**RE: Scooter's Coffee Store #1175  
2509 San Mateo Blvd NE  
Grading and Drainage Plan  
Engineer's Stamp Date: 06-30-2022  
Hydrology File: H17D116**

Based upon the information provided in your submittal received 7/11/2022, the Grading & Drainage Plan **is not** approved for Grading Permit. The following comments need to be addressed for approval of the above referenced project:

## GRADING AND DRAINAGE PLAN

SHEET  
C3.0

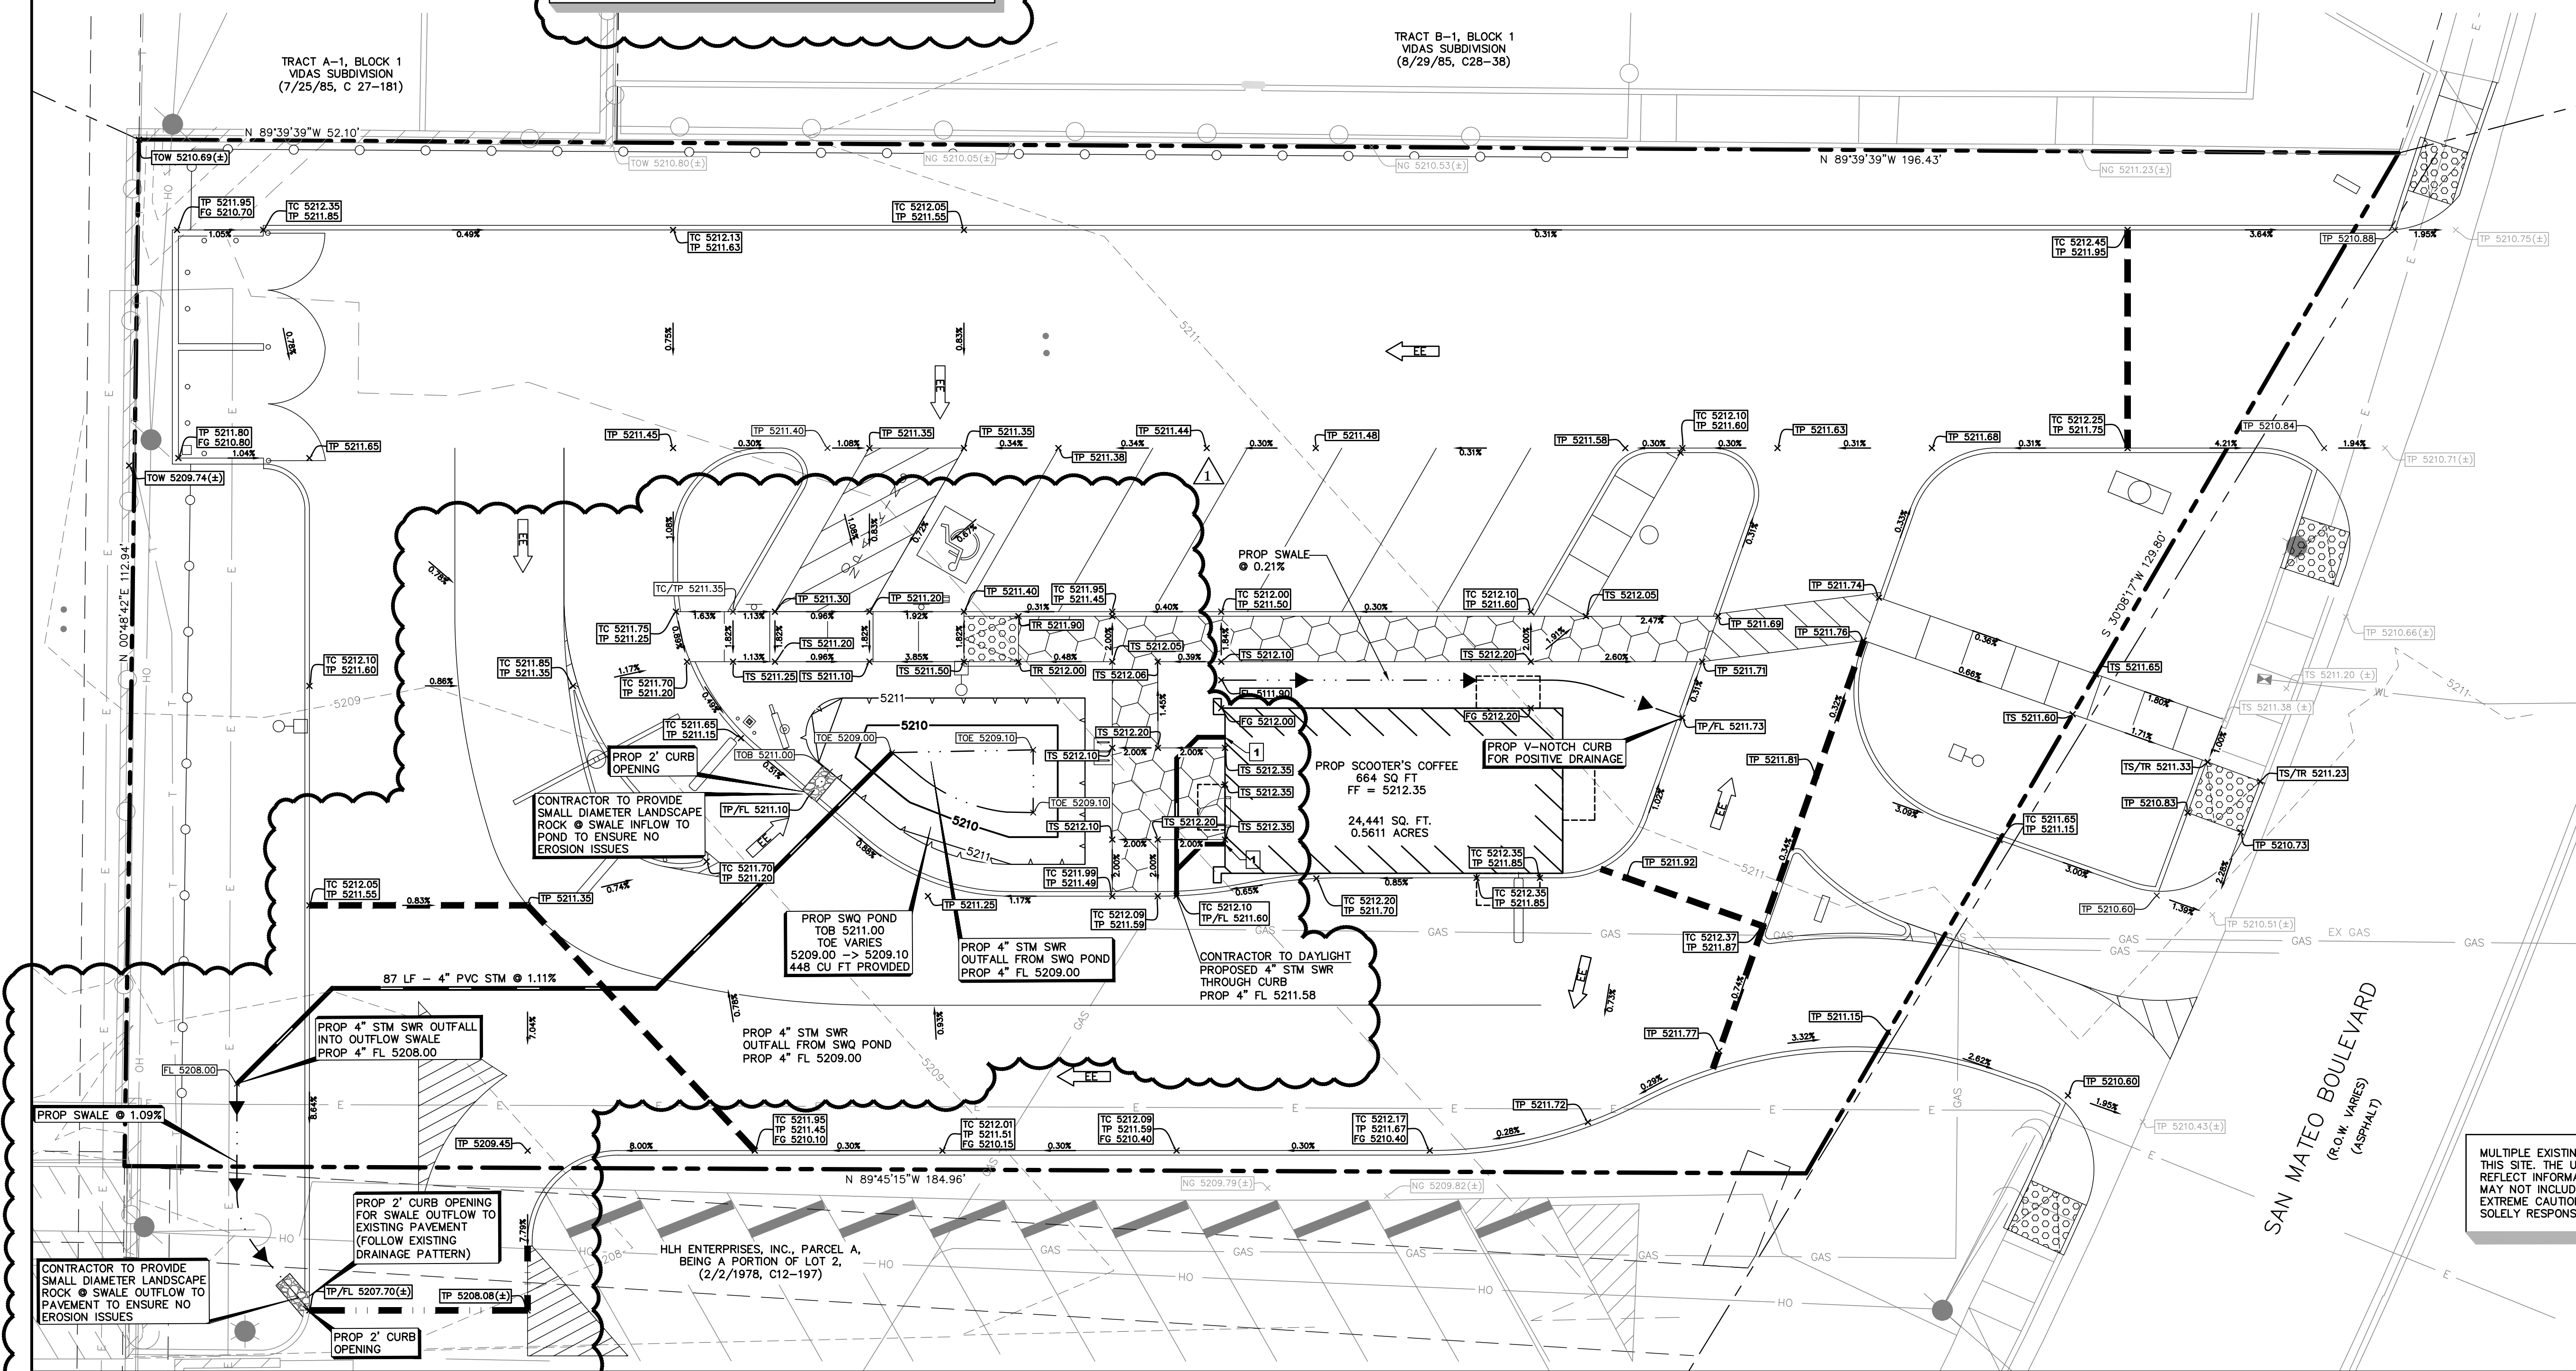
1. The plan clearly needs to communicate what is existing vs. proposed.
  - a. It is not clear and any infrastructure within public right-of-way may need to be constructed via public work order through the Design, Review and Construction Section with the City of Albuquerque.
  - b. Existing vs. proposed and transition?

2. Please provide a section of the proposed Storm Water Quality Pond showing pertinent elevations:
  - a. Bottom of pond
  - b. Top of pond
  - c. Inlet elevation.
  - d. Outlet elevation
  - e. Retained water for storm water quality elevation.

3. Please acquire approval from Transportation and clearly note for the entrance that you will follow standard details for a commercial entrance. (reference the standard detail)

- a. Both entrances should be clarified.
4. Note to match existing grades where applicable as well and show clear distinction where the construction limits are.

5. Does the site have approval to drain into the adjacent property as proposed? If so please reference the document that allows such discharge from the site.

- a. All downstream capacity should be noted as well.
6. It is not necessary to bubble the area for the calculations etc... it made it seem initially that is the only place work/construction is being done.

- a. Please clean this up to clearly depict the entire site is the construction limits or as appropriate.
7. Please include survey points on adjacent lots to show what the proposed infrastructure/grades are tying into.
